ITEM: 6.6	REPORT SUMMARY MINOR VARIANCE APPLICATION FILE NUMBER A054/24
-----------	---

CITY WARD #:	4
APPLICANT:	Barrington Chung and AnnaMay Fung
AGENT:	Custom Pools & Landscaping (Mark Burger)
PROPERTY:	53 Dimarino Drive, Maple
ZONING DESIGNATION:	See below.
VAUGHAN OFFICIAL PLAN (2010) DESIGNATION:	Vaughan Official Plan 2010 ('VOP 2010'): "Low-Rise Residential".
RELATED DEVELOPMENT APPLICATIONS:	None
PURPOSE OF APPLICATION:	Relief from the Zoning By-law is being requested to permit a proposed pool.

#	Zoning By-law 001-2021	Variance requested
1	The minimum setback of the outdoor swimming pool to the rear lot line is 1.5m Section 4.21	To permit a minimum rear setback of 1.30m to the outdoor swimming pool.

POOL PERMIT PLAN  
CLIENT: CHUNG  
ADDRESS: 100 DIMARINO DR., MAPLE  
DATE: MARCH 29, 2024  
SCALE: 1/16" = 1'-0"  
SHEET SIZE: 11 X 17  
DRAWN BY: H. MOYNIHAN  
CHECKED BY: SA-617-2582

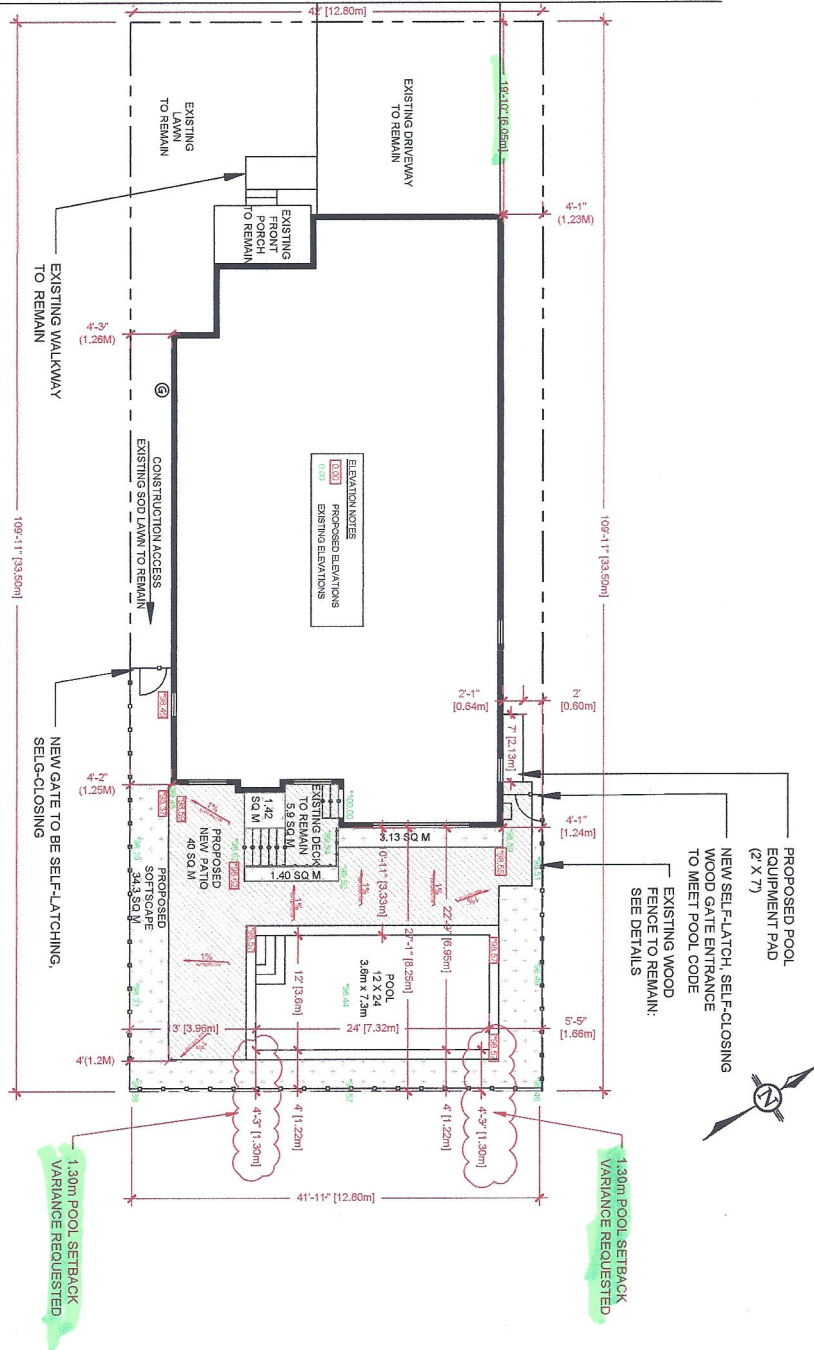
Correct  
6.05m / 19'10"

Development Planning Department Staff have no objection to Variance 1 as the proposed 0.2 m reduction to the rear yard setback is minor in nature, is not anticipated to be perceptible, and maintains an appropriate area for safe access and maintenance.
